Access Compliance Report

Public Rights-of-Way

Intersection ID: 2990	Main Street: THOMAS_RIDGE_DR	Cross Street: PROSPERITY_RIDGE_RD	Location: SE
ADA ID: 9EC795B9F998	Ramp Type: PerpDiag	Initial Pass/Fail: Fail	Overall Compliance: No
Severity Score: 21.25			
Codes/Mitigation Info/Possible Solution		Field Measurements/Component Compliance

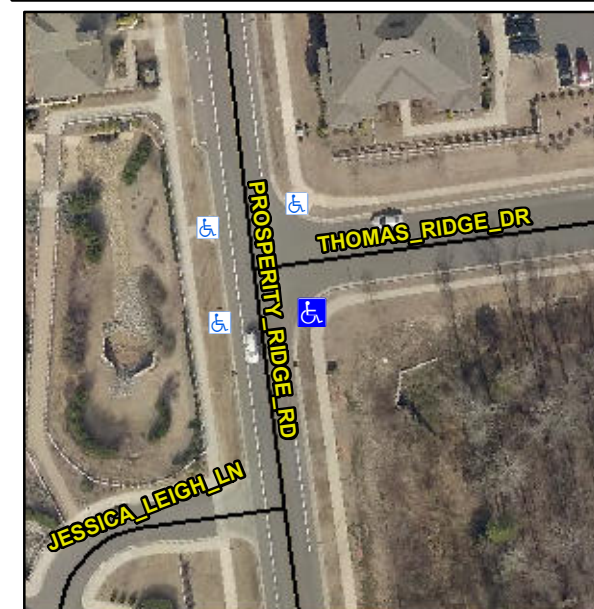
R304.5.1, R304.5.3

Compliance	Description	Data	Compliance	Description	Data
N/A	Ramp Length (in)	55.5	Yes	Ramp Slope (%)	6.3
No	Ramp Width (in)	47.5	No	Ramp XSlope (%)	5.1
N/A	Flare Type LT	N/A	N/A	Flare Type RT	N/A
N/A	Flare Slope LT (%)	N/A	N/A	Flare Slope RT (%)	N/A
N/A	Flare Traversable LT?	N/A	N/A	Flare Traversable RT?	N/A
N/A	Landing Length (in)	N/A	N/A	DWS Provided?	N/A
N/A	Landing Width (in)	N/A	N/A	DWS Contrast?	N/A
N/A	Landing Slope (%)	N/A	N/A	DWS Length (in)	N/A
N/A	Landing X Slope (%)	N/A	N/A	DWS Full Width?	N/A
N/A	Landing Curb? (Y/N)	N/A	N/A	DWS Offset (in)	N/A
N/A	Shared Landing?	N/A			
N/A	Gutter Ponding?	N/A	N/A	Gutter Slope (%)	N/A
N/A	Gutter Lip Ht (in)	N/A	N/A	Gutter X Slope (%)	N/A
N/A	Painted X Walk1?	No	N/A	Painted X Walk2?	No
	X Walk 1 Direction	To N		X Walk 2 Direction	To W
N/A	X Walk 1 Width (in)	N/A	N/A	X Walk 2 Width (in)	N/A
	X Walk 1 Slope (%)	0.2		X Walk 2 Slope (%)	6.7
	X Walk 1 X Slope (%)	9.3		X Walk 2 X Slope (%)	0.5

N/A	Ramp inside XWalk1?	N/A	N/A	Ramp inside XWalk2?	N/A
	Road Slope (%)	6.1	N/A	Clear Space?	N/A
	Road X Slope (%)	3.7	N/A	Clear Space to XWalk (in)	N/A
N/A	Any Obstructions?	N/A	N/A	Storm Grate/Utility Hazard?	N/A
	Obstruction Type			Storm Grate/Utility Type	
		N/A			N/A
		Yes		Surface Condition? (G/P)	Good

Remove & Replace Curb Ramp With Two New Directional Ramps or Equivalent.
